DEVIATION REQUEST AND DECISION FORM

Project Name:	Mountain View Academy
Schedule No.(s):	
Legal Description:	Tract H, Claremont Ranch Filing No. 4 as recorded under Reception No. 204062712 of the records of the El Paso County Clerk and Recorder, County of El Paso, State of Colorado, containing 7.884 Acres or 343,420 Square Feet, more or less.

A deviation from the standards in Appendix I, Section I.7.3 of the Engineering Criteria Manual (ECM) which states that WQCV ponds should be incorporated into Minor- and 100-Year Storm Stormwater Detention Structures is requested. This deviation request also applies to Chapter 13 of the Drainage Criteria Manual Vol. 1 Update (DCM v1 update) regarding full-spectrum ponds and EURV as well as Board of County Commissioners resolution 15-042 stating that the “most restrictive” requirements shall apply.

proposed pond cross section showing full use of available stage - storage

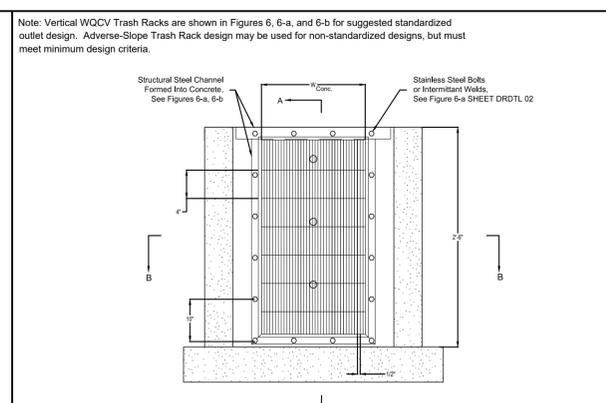
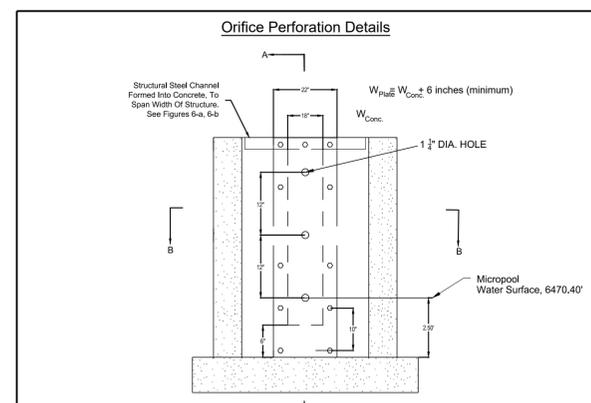
While not ideal, the compensating “over detention” provides twice the minimum required WQCV and roughly half the specified EURV while making full available use of the stage / storage available based on the existing storm sewer invert and top-back-of inlet (overflow point).

The depth of the storm sewer at the provided tie-in point does not allow for the stage-range required for a fully functioning full-spectrum pond. Previous design of the surrounding development provided for flood attenuation requirements in effect at the time (10-year and 100-year). The site will still be served by the regional detention facility as described in the *Final Drainage Report for Claremont Ranch, Filing 4*. The engineer has worked with the available stage / storage to provide compensatory over-detention equating to roughly twice the required WQCV and ½ the specified EURV volume. Serial flood attenuation, as suggested, may violate SB15-212 and if a full-spectrum pond were possible, it would be of a size, depth, and release regimen that could prove to be a life-safety hazard for young students who would naturally be attracted to such a feature.

This request has been determined to have met the criteria for approval. A deviation from Section Res 15-042, FSD of the ECM is hereby granted based on the justification provided.

Copy of the Drainage Map from the Preliminary Drainage Report, 1st Submittal

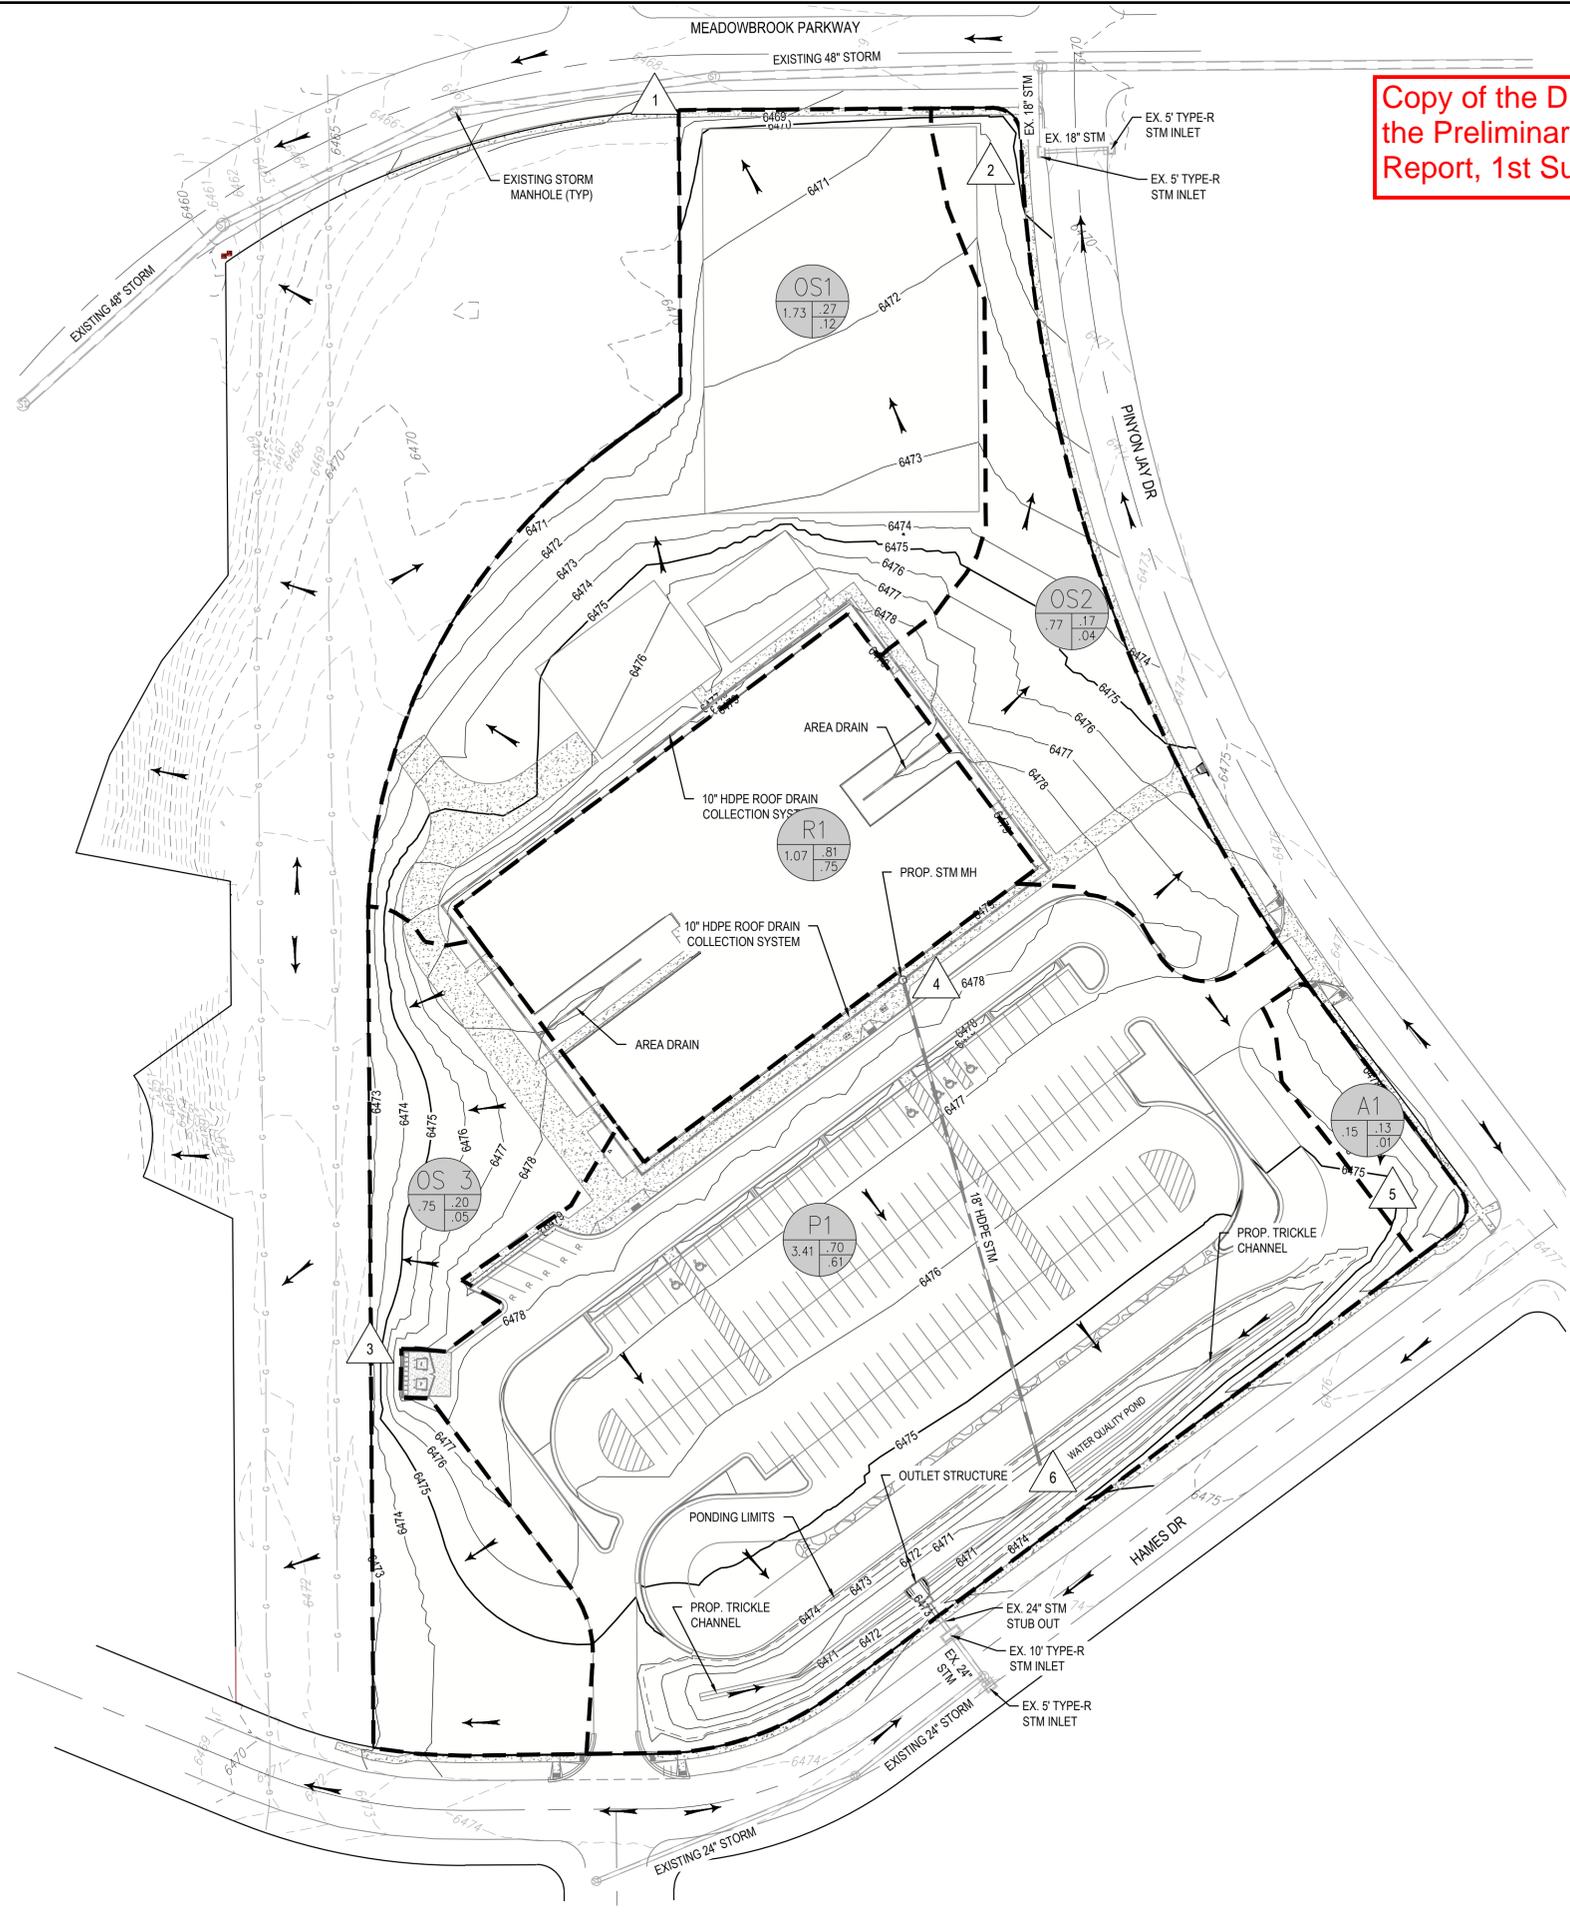
The “over-detention” for the WQCV calculated on 7.88 acres equates to a volume of 0.21 acre-feet. If we were to calculate the WQCV solely on tributary areas (Basins P1, R1) consisting of the parking lot and building roof top, we arrive at a 0.12 acre-foot WQCV requirement for the 4.48 tributary acres while the EURV totaled 0.47 acre-feet.

Deviation Exhibit

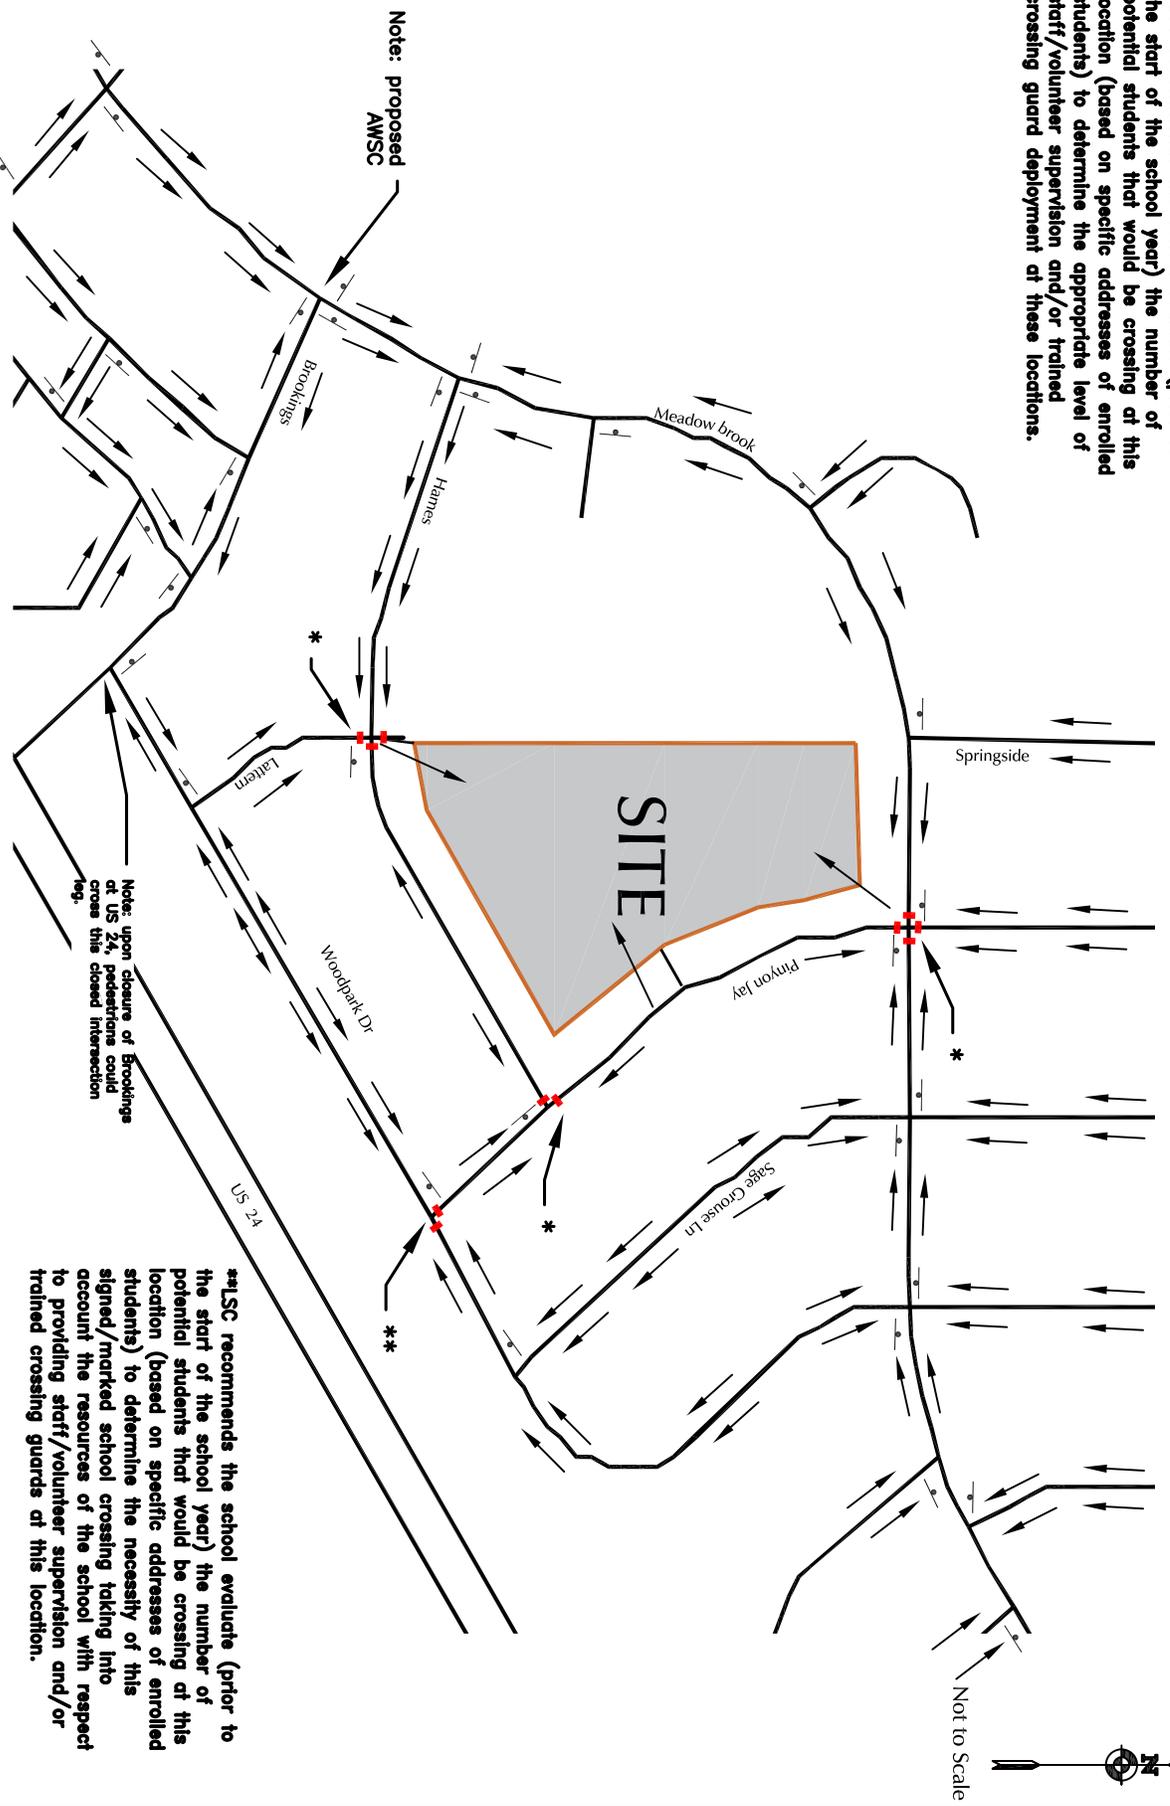
A deviation from the standards of or in Section **2.5.2.C.4** of the Engineering Criteria Manual (ECM) is requested. The existing pedestrian ramp on Pinyon Jay Drive between Meadowbrook Parkway and Hames Drive is proposed to be removed with this project. Please refer to the attached Deviation Exhibit.

It is proposed that mid-block pedestrian ramps be removed (and no designated crossing be provided) on Pinyon Jay Drive between Meadowbrook Parkway and Hames Drive. As a result, the access ramps would be spaced approximately 665 feet apart rather than the 600-foot minimum in the ECM standards. The resulting distance would exceed the minimum distance in the ECM by 65 feet. Applicable figures from the TIS report are attached which show the pedestrian routing plan absent this crossing location.

Removal of this particular set of mid-block ramps and utilizing the access ramps at the intersections identified in the attached figures would result in the minimum distance in the ECM distance being exceed by 65 feet. If these ramps were to remain, it would result in the need for another formal crossing location, which would be unnecessary. A crossing at this location would likely add the need for school supervision or to be staffed by trained crossing guards. Based on the school routing plan, this change would only impact students that live in the houses on Pinyon Jay Drive directly across from the school. All other pedestrians would have an opportunity to cross at Meadowbrook Parkway or Hames Drive without having to travel out-of-direction. Because this is a charter school and not a local school, it is anticipated this would have little to no impact on those potential pedestrians (if any).

This request has been determined to have met the criteria for approval. A deviation from Section 2.5.2.C.4 of the ECM is hereby granted based on the justification provided.

School Route Plan

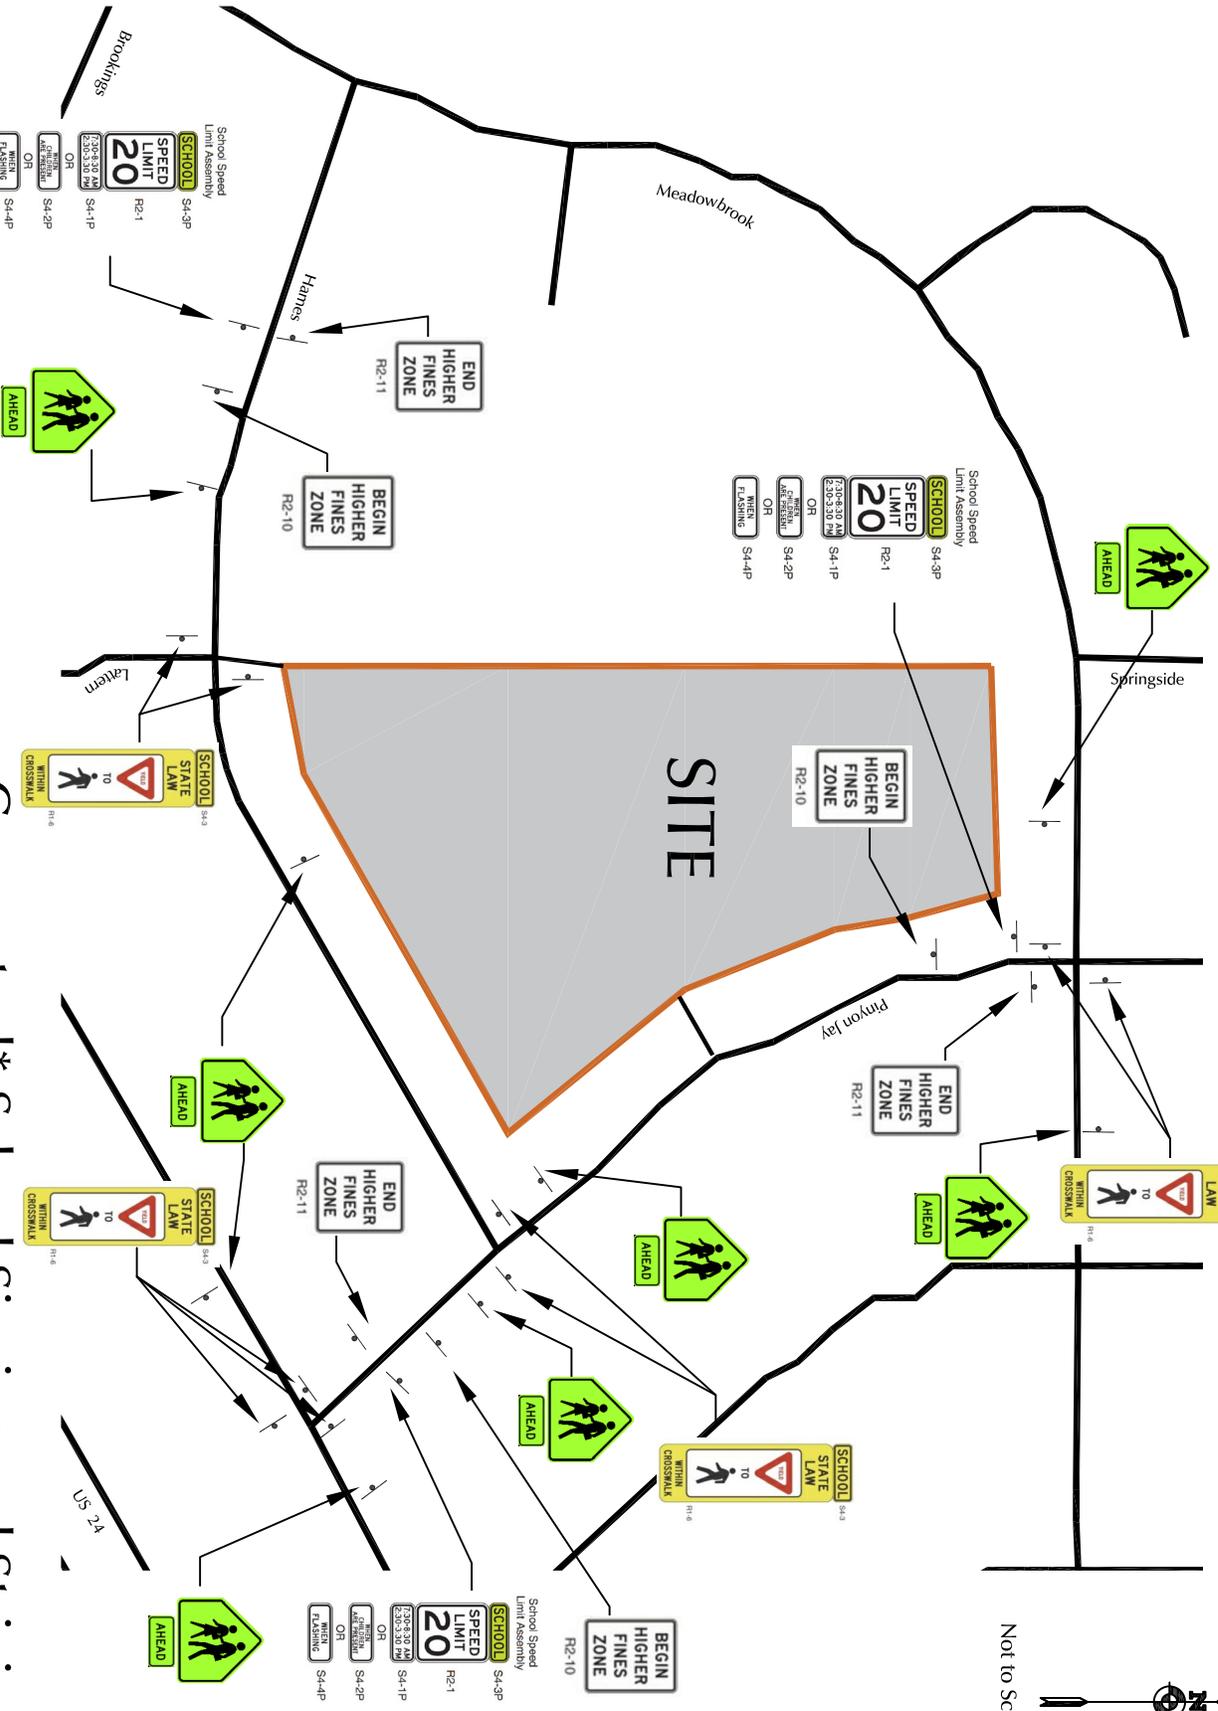
The intention of providing a mid-block crossing a minimum of every 600 feet is to limit out-of-direction travel for pedestrians, therefore increasing the number of pedestrians that cross at crosswalks. The applicable TIS figures showing the school pedestrian routing plan are attached, which demonstrate an effective plan without this crossing. It is anticipated that a mid-block crossing on Pinyon Jay Drive would not be useful for many pedestrians walking to Mountain View Academy. Very few, if any, pedestrians would be required to walk out-of-direction without a mid-block crossing on Pinyon Jay Drive. As a result, it is not expected to have an impact on pedestrians. While at the same time, it removes an unnecessary mid-block crossing, reducing potential driver confusion and issues with the planned Mountain View Academy access on Pinyon Jay Drive.

**LSC recommends the school evaluate (prior to the start of the school year) the number of potential students that would be crossing at this location (based on specific addresses of enrolled students) to determine the necessity of this signed/marked school crossing taking into account the resources of the school with respect to providing staff/volunteer supervision and/or trained crossing guards at this location.
